SUNDRY NOTICES AND REPORTS ON WELLS
Do not use this form for proposals to drill or to re-enter an abandoned well. Use form 3160-3 (APD) for such proposals.

8. Well Name and No.
DOGWOOD 23 FED COM 703H

EOG Resources requests an amendment to our approved APD for this well to reflect a change in casing design as attached.

Proposed Wellbore
Revised 11/2/17
API: 30-025-44075

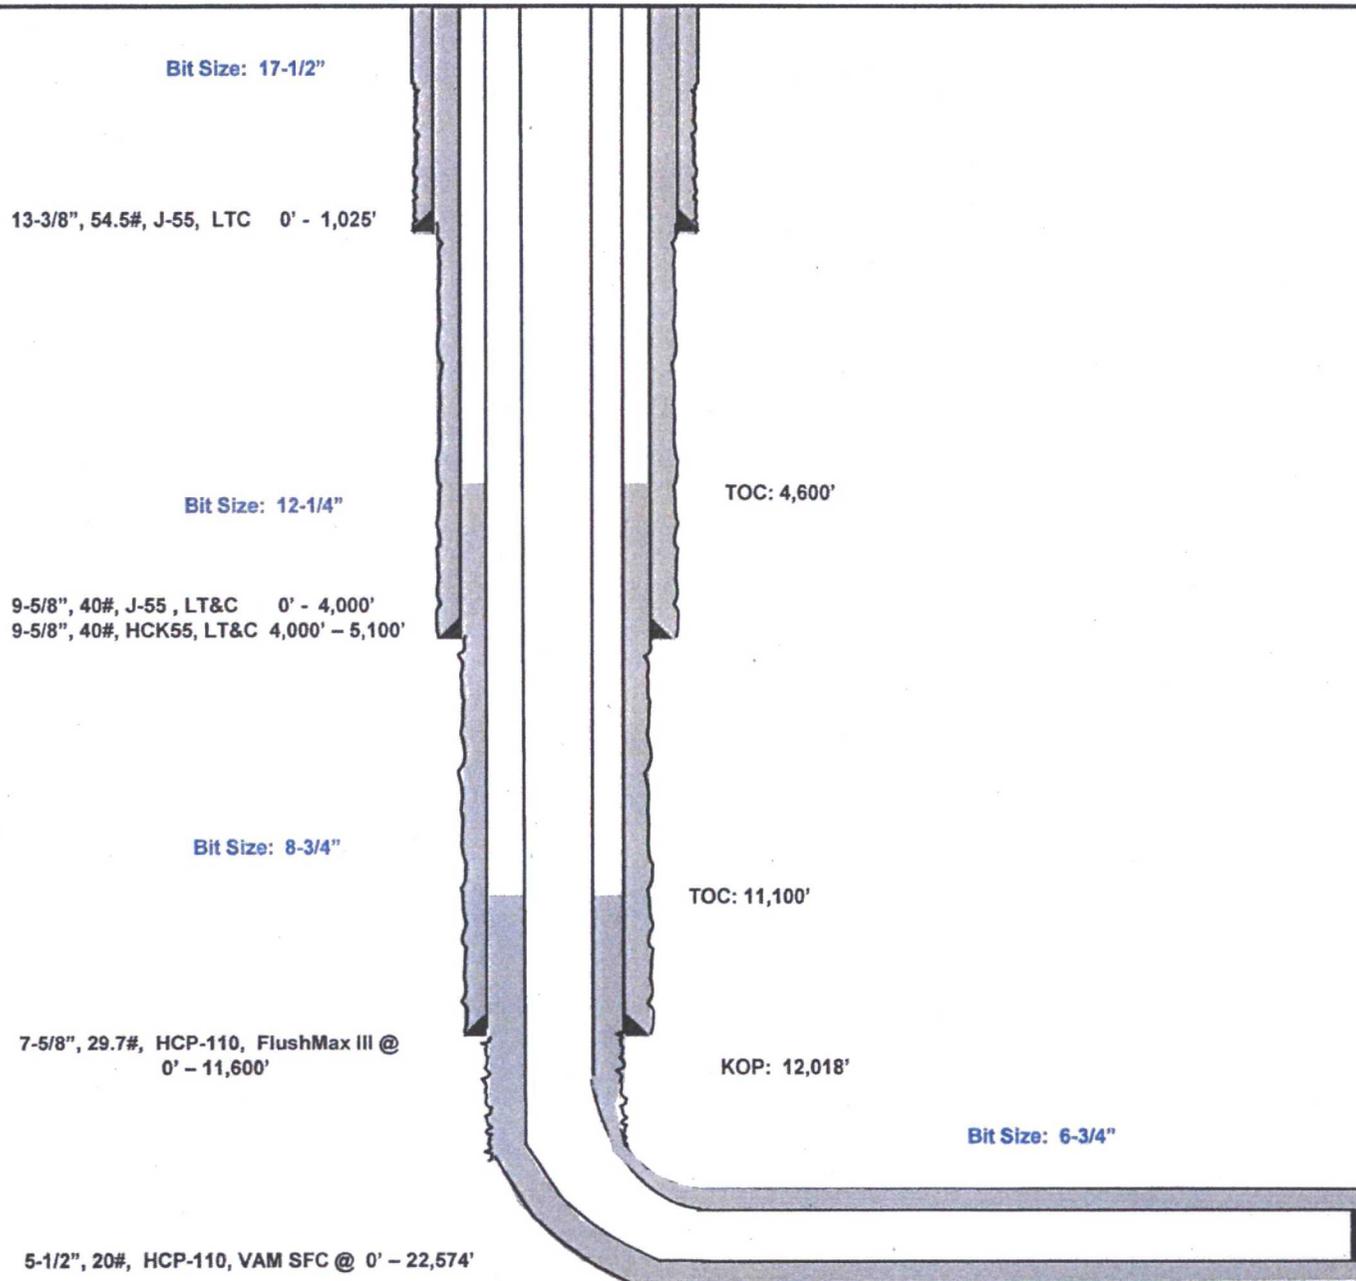
Revised Permit Information 11/2/17:

Hole Size	Interval	Csg OD	Weight	Grade	Conn	DF _{min} Collapse	DF _{min} Burst	DF _{min} Tension
17.5"	0 - 1,025'	13.375"	54.5#	J55	STC	1.125	1.25	1.60
12.25"	0-4,000'	9.625"	40#	J55	LTC	1.125	1.25	1.60
12.25"	4,000' - 5,100'	9.625"	40#	HCK55	LTC	1.125	1.25	1.60
8.75"	0 - 11,600'	7.625"	29.7#	HCP-110	FlushMax III	1.125	1.25	1.60
6.75"	0'-22,574'	5.5"	20#	HCP-110	VAM SFC	1.125	1.25	1.60

Depth	No. Sacks	Wt. lb/gal	Yld Ft ³ /ft	Water Gal/sk	Slurry Description
1,025'	600	13.5	1.74	9.13	Lead: Class 'C' + 4.00% Bentonite + 2.00% CaCl ₂ (TOC @ Surface)
	300	14.8	1.35	6.34	Tail: Class 'C' + 0.6% FL-62 + 0.25 lb/sk Cello-Flake + 0.2% Sodium Metasilicate + 2.0% KCl (1.06 lb/sk)
5,000'	1780	12.7	2.20	11.64	Lead: Class C + 0.15% C-20 + 11.63 pps Salt + 0.1% C-51 + 0.75% C-41P (TOC @ Surface)
	200	16.0	1.12	4.75	Tail: Class C + 0.13% C-20
11,600'	340	11.5	2.72	15.70	Lead: Class C + 0.40% D013 + 0.20% D046 + 0.10% D065 + 0.20% D167 (TOC @ 4,500')
	210	16.0	1.12	4.74	Tail: Class H + 94.0 pps D909 + 0.25% D065 + 0.30% D167 + 0.02% D208 + 0.15% D800
22,574'	950	14.1	1.26	5.80	Class H + 0.1% C-20 + 0.05% CSA-1000 + 0.20% C-49 + 0.40% C-17 (TOC @ 11,100')

Depth	Type	Weight (ppg)	Viscosity	Water Loss
0 - 1,025'	Fresh - Gel	8.6-8.8	28-34	N/c
1,025' - 5,100'	Brine	10.0-10.2	28-34	N/c
5,100' - 11,600'	Oil Base	8.7-9.4	58-68	N/c - 6
11,600' - 22,574' Lateral	Oil Base	10.0-11.5	58-68	3 - 6
